## DETERMINATION OF NON-SIGNIFICANCE

**FILE NUMBER:** 07-143038-LK

**City of Bellevue  
Development Services Department  
Land Use Staff Report**

Proposal Name: Meydenbauer Bay Townhomes  
Proposal Address: 312 101<sup>st</sup> Ave SE  
Proposal Description: Application for Planned Unit Development and Preliminary Plat with SEPA for 22 single family units on a .81 acre site zoned R-30  
File Number: 07-143038-LK  
Applicant: John Sullivan, Northwest Townhomes, LLC  
Decisions Included: Process I  
Planner: Heidi M. Bedwell  
State Environmental Policy Act Threshold Determination: Determination of Non-Significance

Existing and proposed Building Height

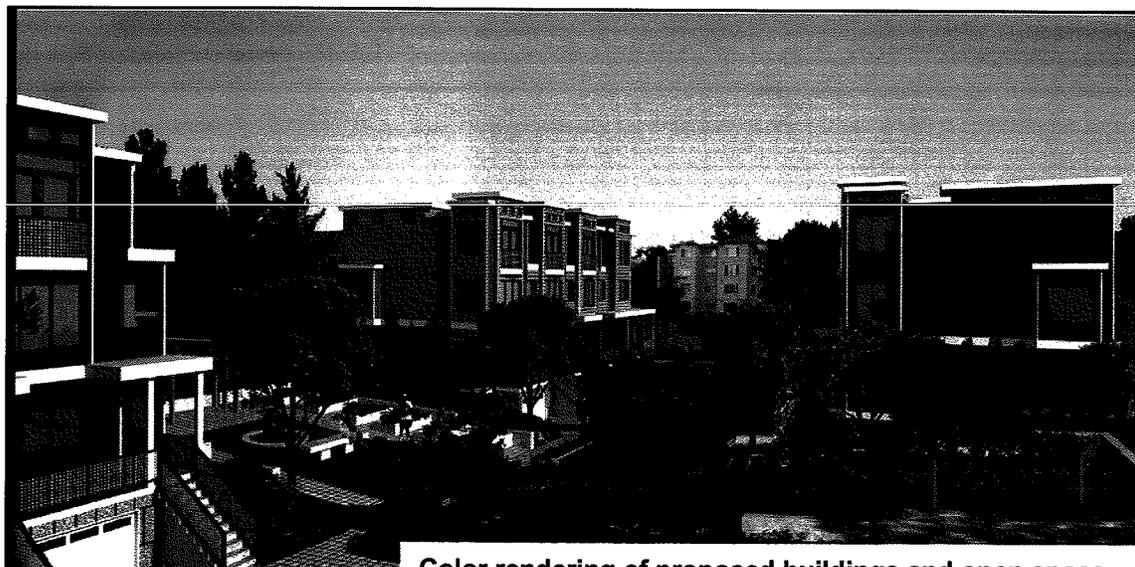
**Question/Issue: What will the height of the proposed building be in relation to the existing structures?**

**Response:** Attachment C depicts the height and mass of the existing buildings relative to the proposed structures. Buildings 3 and 4 are less than two feet taller than the existing building in that approximate location. Building 1 and 6 are approximately 7 feet taller than the existing building on the western portion of the site. The proposed structures are less than the 40 foot height allowed within the R-30 zoning district. The structures to the north are at higher elevation and are taller than both the existing and proposed structures.
